Caltrans Hwy 1 vegetation management in Montara

Midcoast Community Priorities:

Midcoast Community Council
March 18, 2018
http://www.midcoastcommunitycouncil.org

10^{th} St.

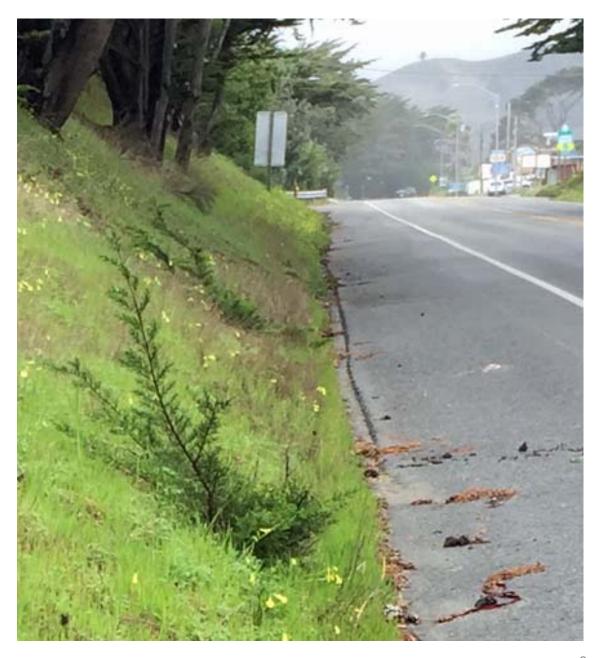
Remove 3 small dead staked cypress trees from view corridor.

Prune encroaching lower cypress branches off at the trunk, instead of stub cuts, which quickly regrow, or die and look unsightly.
